Access Compliance Report

Public Rights-of-Way

Intersection ID: 5058	Main Street: KILLARNEY_PL	Cross Street: MORNING_GLORY_DR	Location:	N
ADA ID: 0843C49E984F	Ramp Type: Perp	Initial Pass/Fail: Fail	Overall Compliance: No	Severity Score: 50

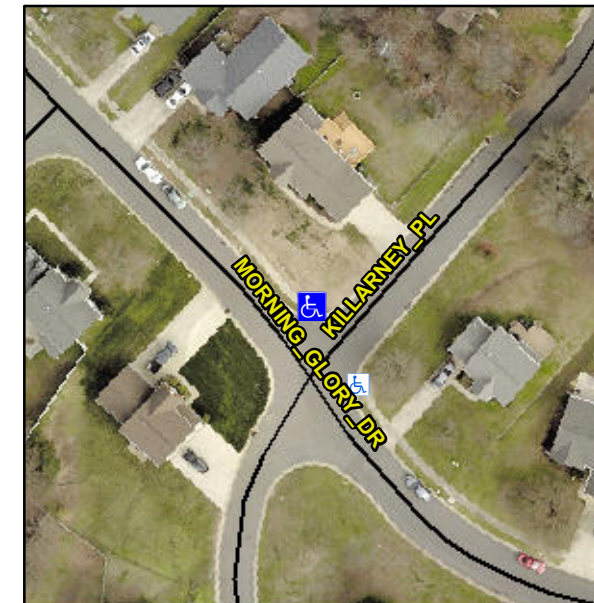
Not Found, R304.2.2, R304.5.3

Compliance	Description	Data	Compliance	Description	Data
N/A	Ramp Length (in)	45.0	No	Ramp Slope (%)	13.4
Yes	Ramp Width (in)	48.0	No	Ramp XSlope (%)	11.8
N/A	Flare Type LT	N/A	N/A	Flare Type RT	N/A
N/A	Flare Slope LT (%)	N/A	N/A	Flare Slope RT (%)	N/A
N/A	Flare Traversable LT?	N/A	N/A	Flare Traversable RT?	N/A
N/A	Landing Length (in)	N/A	N/A	DWS Provided?	N/A
N/A	Landing Width (in)	N/A	N/A	DWS Contrast?	N/A
N/A	Landing Slope (%)	N/A	N/A	DWS Length (in)	N/A
N/A	Landing X Slope (%)	N/A	N/A	DWS Full Width?	N/A
N/A	Landing Curb? (Y/N)	N/A	N/A	DWS Offset (in)	N/A
N/A	Shared Landing?	N/A			
N/A	Gutter Ponding?	N/A	N/A	Gutter Slope (%)	N/A
N/A	Gutter Lip Ht (in)	N/A	N/A	Gutter X Slope (%)	N/A
N/A	Painted X Walk1?	No	N/A	Painted X Walk2?	N/A
	X Walk 1 Direction	To SE		X Walk 2 Direction	N/A
N/A	X Walk 1 Width (in)	N/A	N/A	X Walk 2 Width (in)	N/A
	X Walk 1 Slope (%)	7.2		X Walk 2 Slope (%)	N/A
	X Walk 1 X Slope (%)	0.4		X Walk 2 X Slope (%)	N/A

Remove & Replace Entire Ramp.
